**MAPLE SHADE BOARD OF EDUCATION
MAUDE WILKINS ELEMENTARY SCHOOL CLASSROOM ADDITION, Bid Number
19-105
Addendum #2
December 5, 2019**

Bid Package Clarification and Changes

AC-01

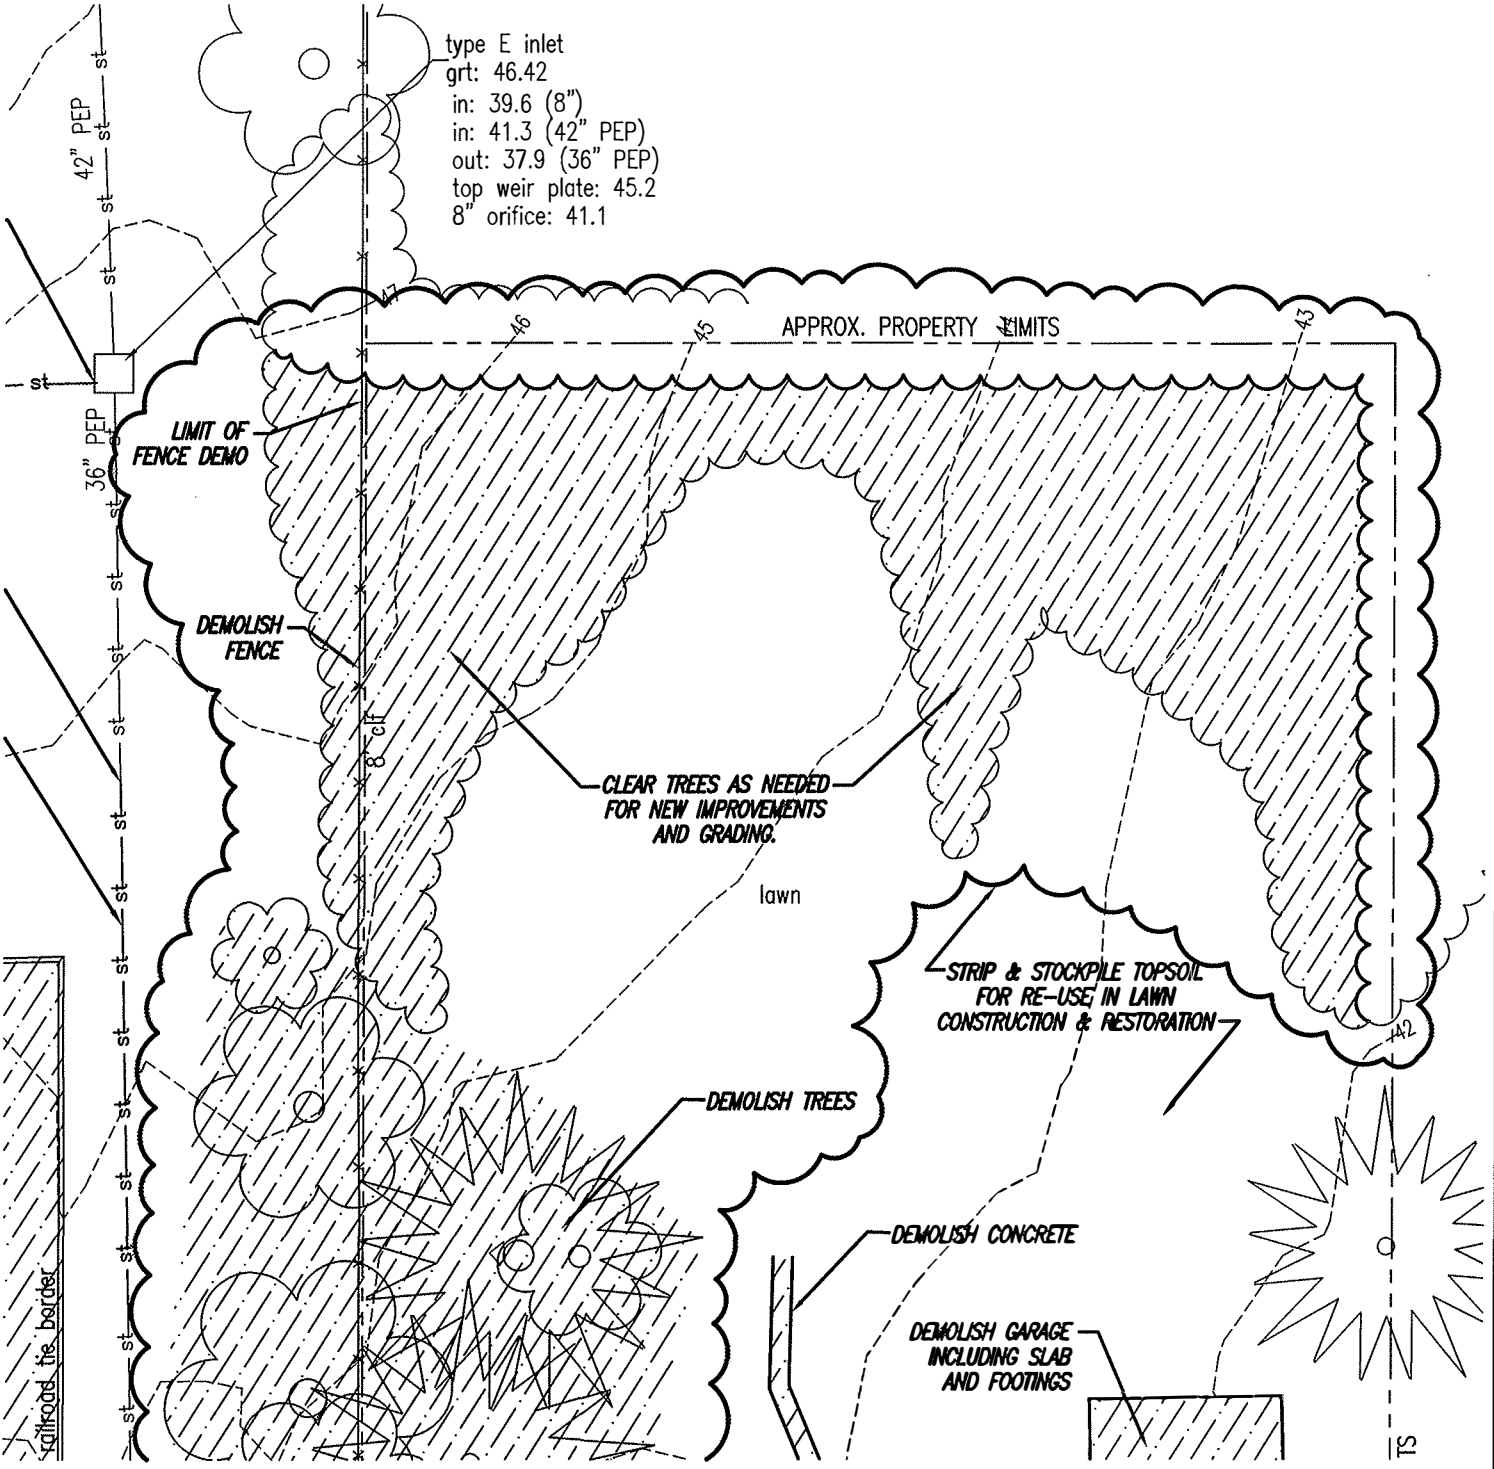
3. On Drawing C-2, the tree clearing limits have been expanded, and tree demolition clarified with hatch and labels. **See the attached Sketches AC-01 and AC-02.**

CLARIFICATION OF TREE DEMOLITION
REF. DWG C-2

PROJECT NAME: MAUDE WILKINS ELEMENTARY SCHOOL CLASSROOM ADDITION
PROJECT NUMBER: 1356B
DATE: 12.03.19
ADDENDUM SKETCH AC-04

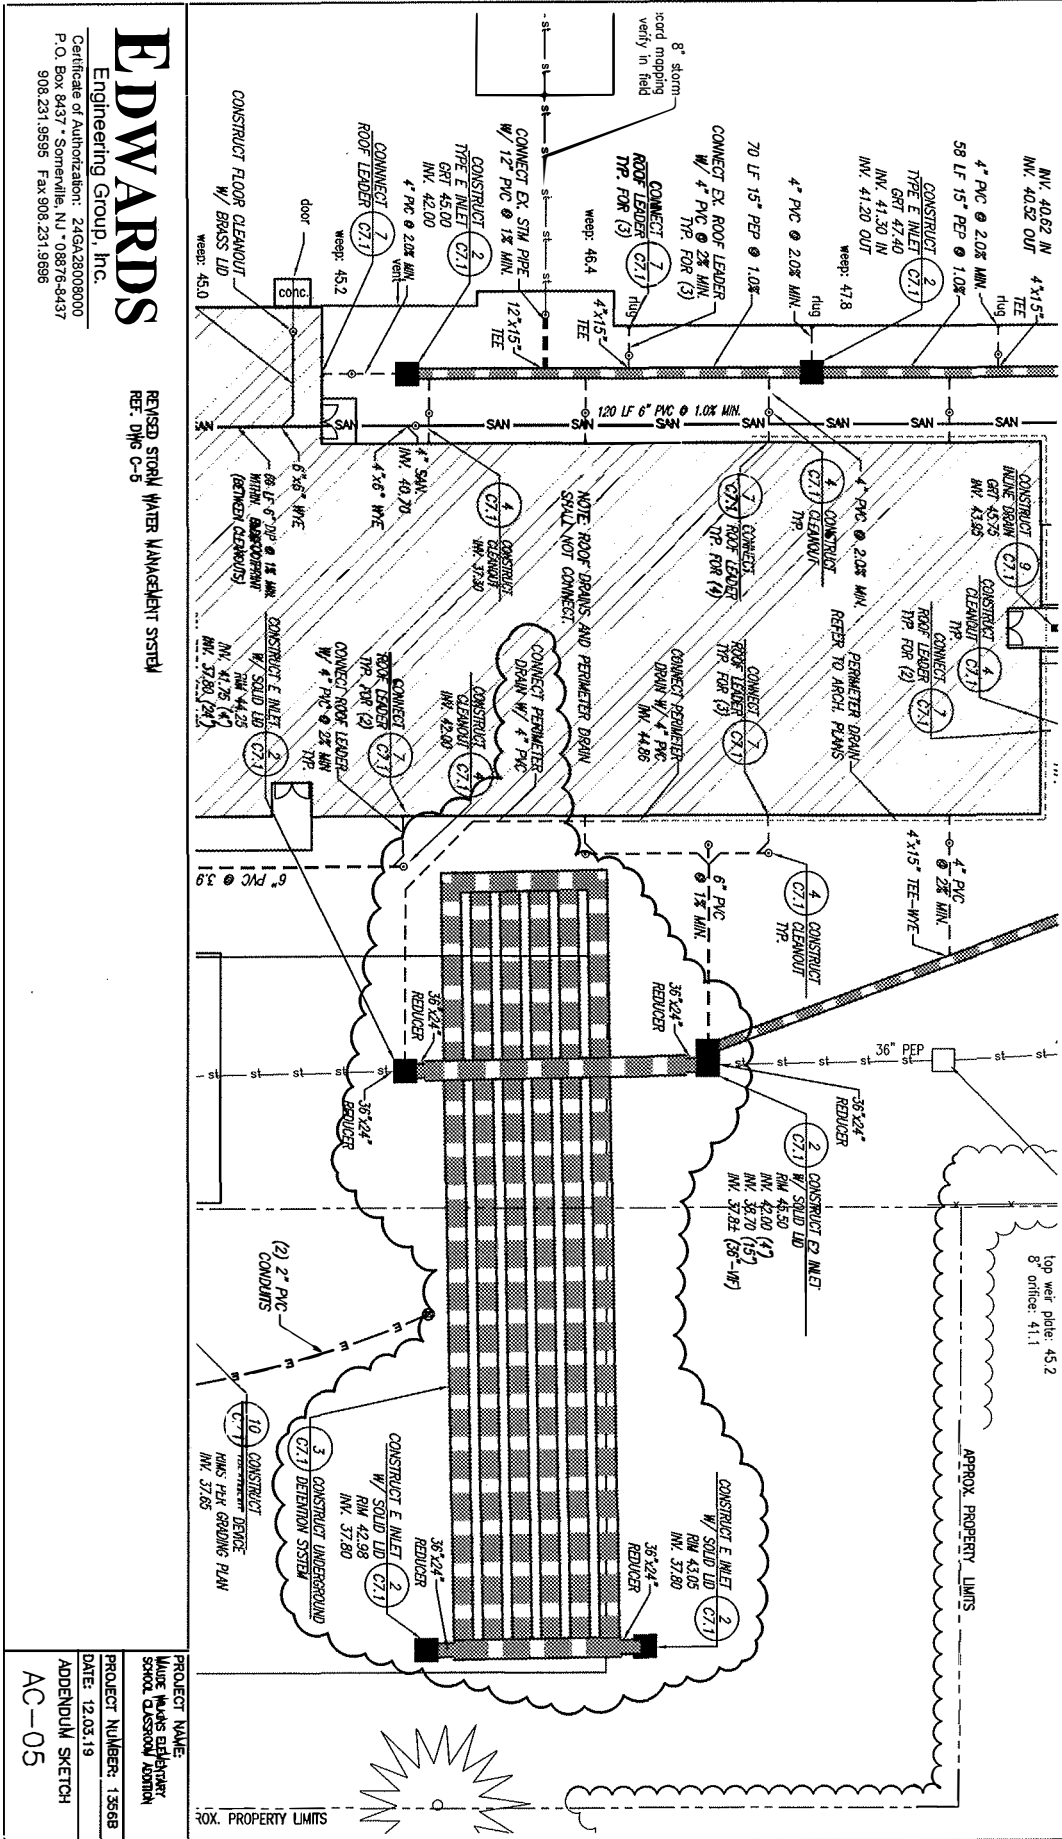
5. On Drawing C-4, proposed grading has been adjusted to accommodate the smaller parking lot. **See the attached Sketch AC-04.**
6. On Drawing C-5, the layout of the proposed underground storm water management system has been revised to remain within the footprint of the smaller parking lot. **See the attached Sketch AC-05.**

REVISED GRADING FOR SMALLER
 GRAVEL LOT
 REF. DWG C-4

AC-06

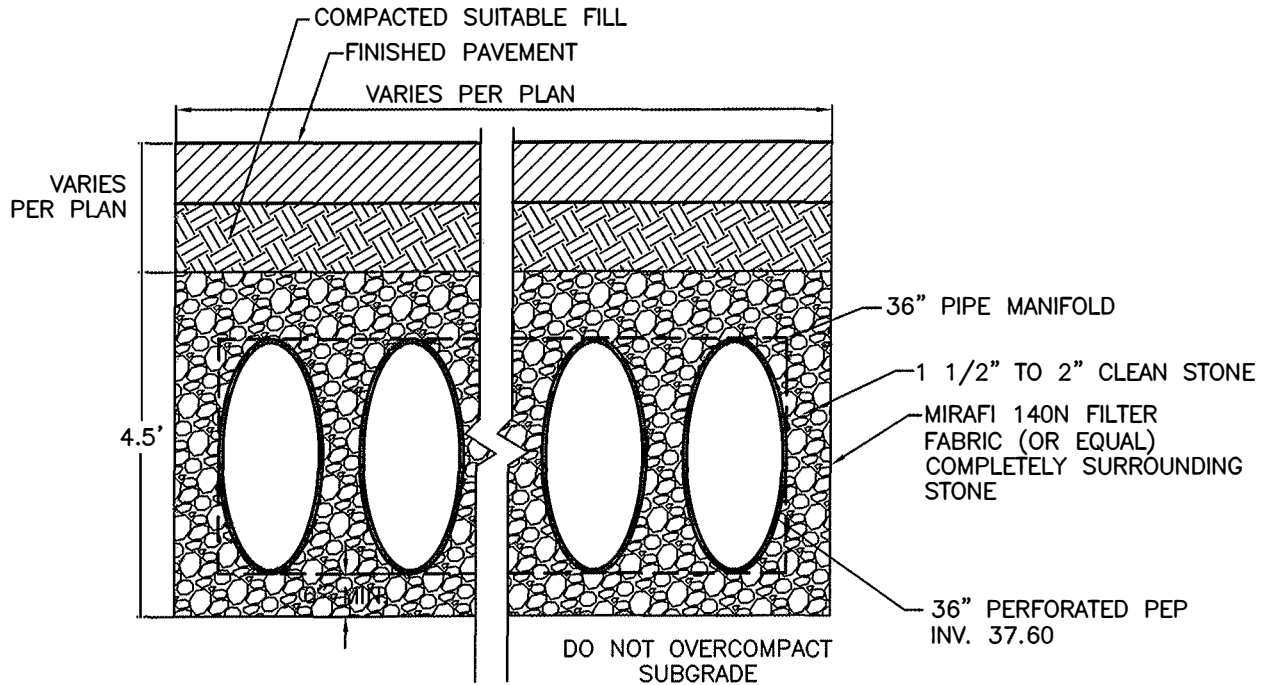
7. On Drawing C-7.1, the details for the Outflow Structure and the Underground Storm Water Detention System have been slightly revised. **See the attached Sketches AC-06 and AC-07.**

REVISED DETAIL 5/C-7.1
 UNDERGROUND OUTFLOW STRUCTURE
